SEQUOYAH NUCLEAR PLANT - RESPONSE TO REQUEST FOR ADDITIONAL
INFORMATION - TECHNICAL SPECIFICATION (TS) CHANGE REQUEST 96-01 ON
CONVERSION TO COGEMA FUEL (TAC NOS. M95144 AND M95145)

NRC RAI ON TS 96-01

REQUEST FOR ADDITIONAL INFORMATION
TENNESSEE VALLEY AUTHORITY
SEQUOYAH NUCLEAR PLANT, UNITS 1 AND 2
DOCKET NUMBERS 50-327 AND 50-328

Figure 5.9-1 RELAP5 Small Break LOCA Model
Sequoyah Noding for Reactor Vessel and Core

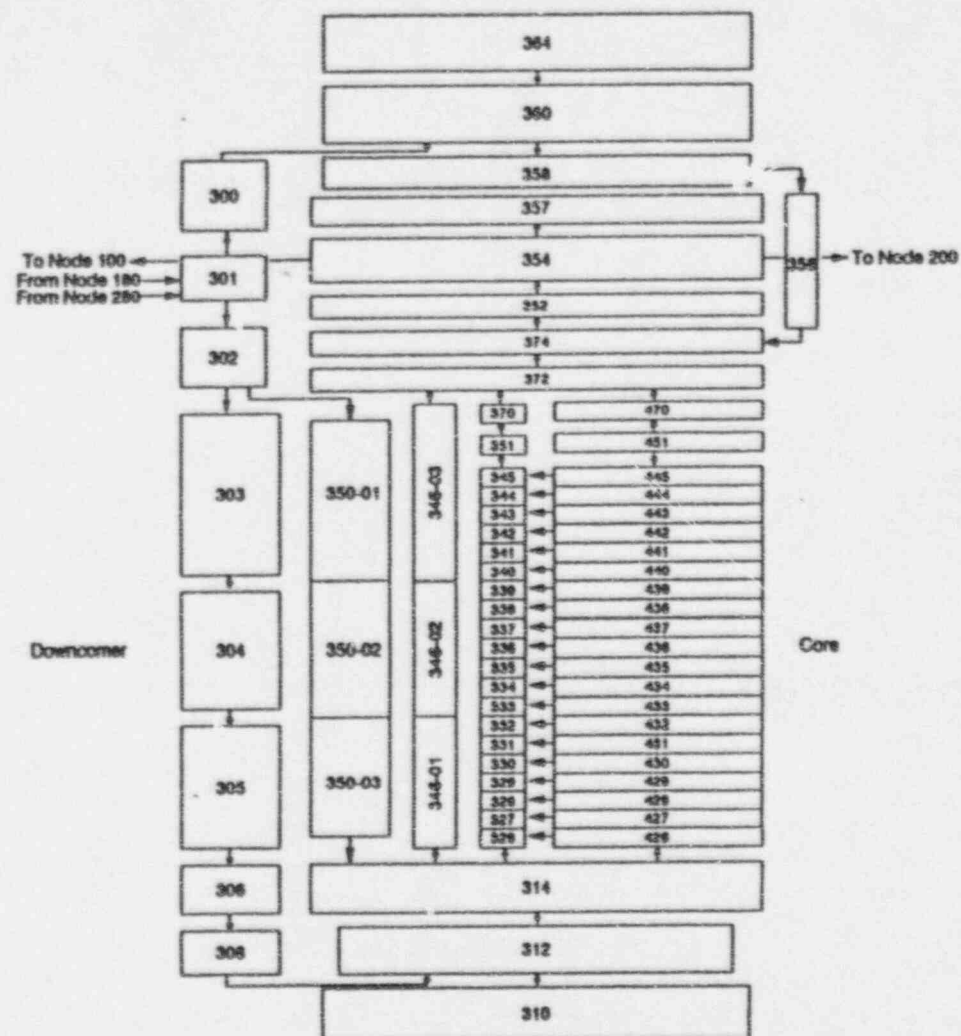
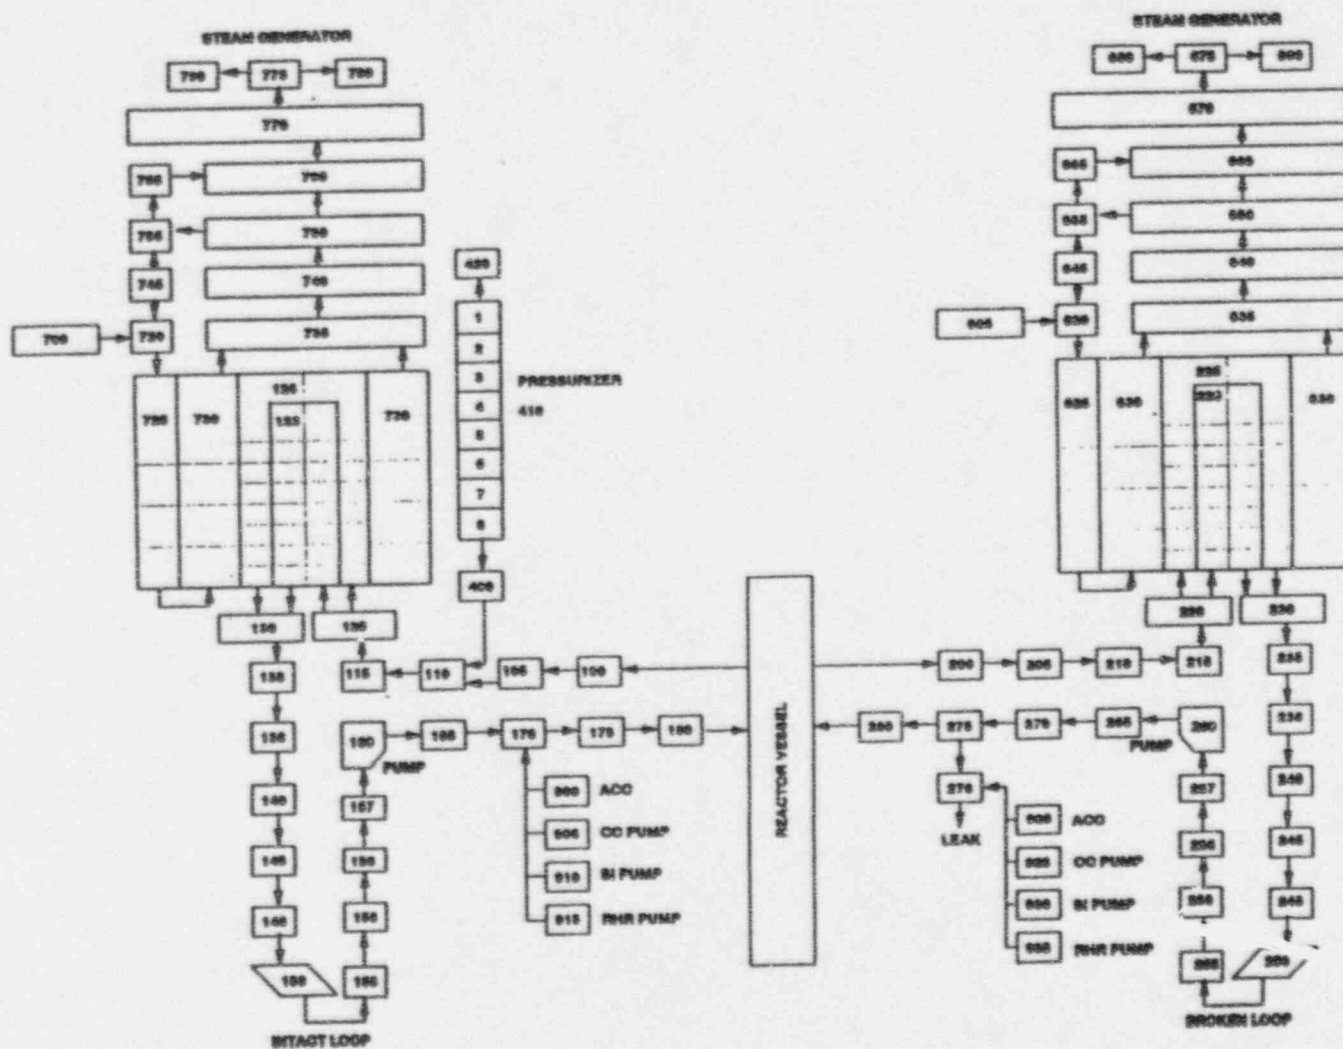
1. Revision 2 to the BAW-10168 evaluation model was modified during the staff review with regard to the Moody break flow model and discharge coefficient. Please verify that the analysis that was used to support this Sequoyah Nuclear Plant (SQN) fuel change and Technical Specification (TS) amendment was performed using the approved model.

Several modifications were made to FCF's small break LOCA evaluation model, BAW-10168, Revision 2, in response to the NRC review of the document. Chief among these modifications - with respect to the SQN small break LOCA analyses - are changes to the break discharge coefficient and the nodalization of the pump suction piping (the original evaluation model implemented a variable 0.7/1.0 discharge coefficient, the approved model requires the use of a constant 1.0 discharge coefficient and the upflow side of the pump suction piping is more finely divided to better predict the occurrence of loop seal clearing). The approved model was utilized to revise the SQN small break analyses. The results of the reanalysis are attached for your consideration. Note that the primary changes to the results are: (1) a shift in the worst case break from a 3-inch break to a 2.5-inch break and (2) an increase in PCT of about 25°F.

RELAP5 is used to predict the reactor coolant system thermal-hydraulic responses to a small break LOCA. The code has been approved by the NRC for licensing application and is documented in detail in Reference 5-3. RCS nodalization is based on the model described in Volume II of the NRC-approved BWNT RSG LOCA EM, Reference 5-1. Nodal diagrams of the SQN small break LOCA model are presented in Figures 5.9-1 and 5.9-2. The small break LOCA model is similar to that used in the large break analyses.

Table 15 - 1
Summary of Non-LOCA Assessment for Reload with Mark-BW Fuel

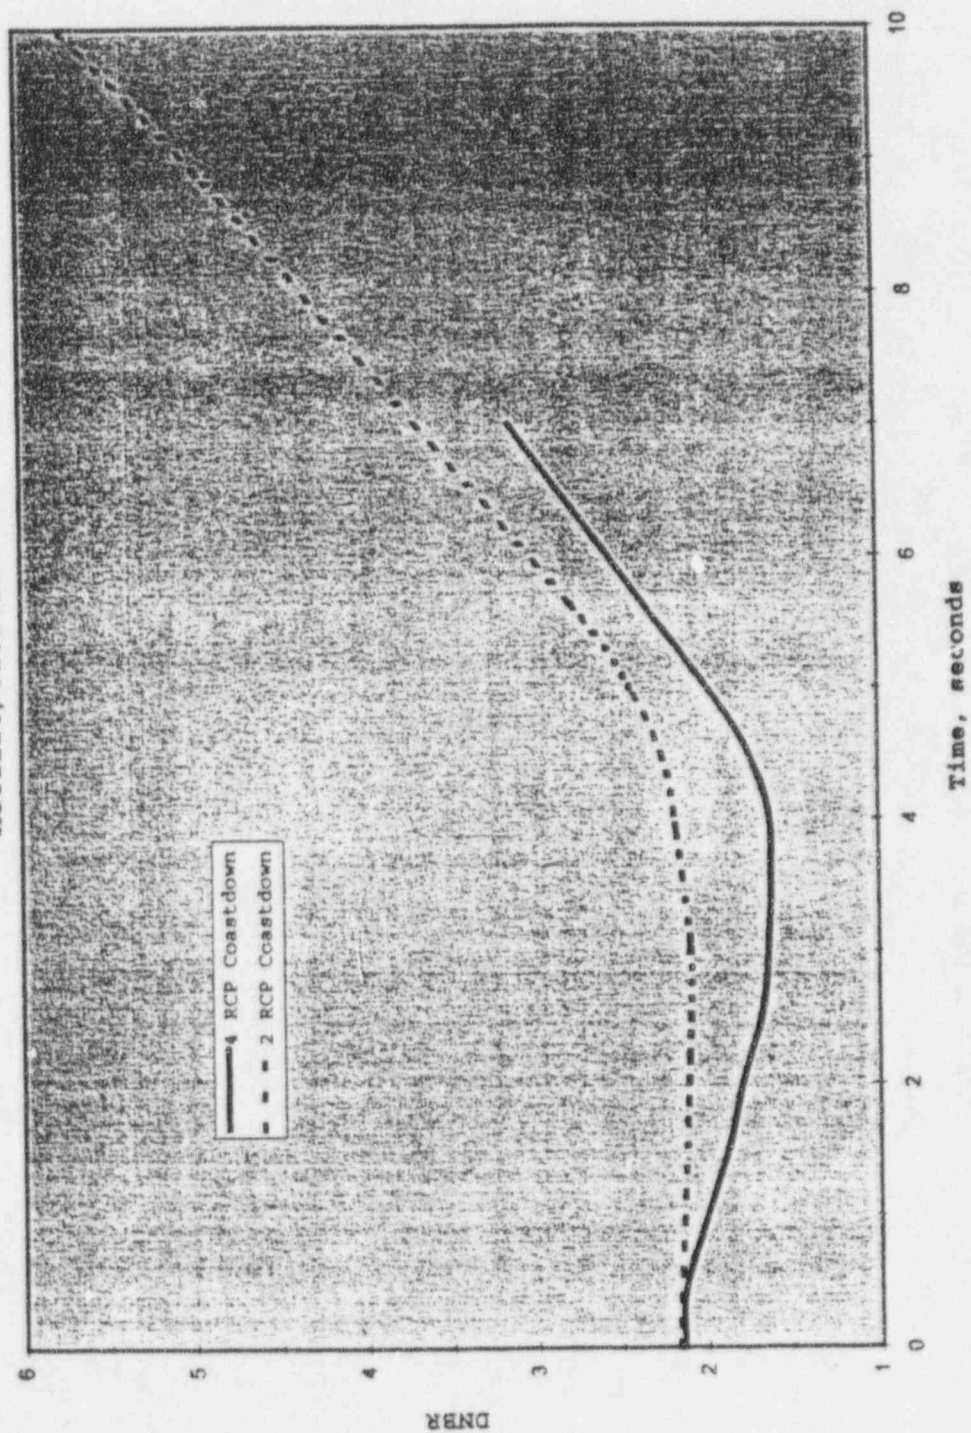
15. It is unclear from the submittal which of the Chapter 15 analyses were redone to support the fuel change and which ones were re-evaluated. Table 6.1-1 is not consistent with the verbiage in text on a number of examples. Table 6.1-1 only lists six transients that were reanalyzed; however, analysis results are discussed for other transients (for example, misaligned RCCA discusses results in Section 6.2.3).

To clarify the situation, state for each Chapter 15 transient whether it was reanalyzed using the Framatome methods with acceptable results or why reanalysis is not necessary (why current analysis remains bounding with the new fuel and a lower RCS flowrate). Include both the effects of the new fuel and the lower RCS flow.

It should be noted that the limiting events with respect to RCS flow are contained in the events chosen for the support of the fuel reload as the events that are also bounding in DNB (Condition II - RCCA withdrawal at power, Condition III - four pump coastdown, and Condition IV - locked rotor). All of the limiting event successfully demonstrate adherence to the relevant acceptance criteria. FCF will, however, compile an evaluation of the Chapter 15 events that is independent of this response. The evaluation will directly demonstrate compliance with the NRC topical query regarding lowered RCS technical specification limits.
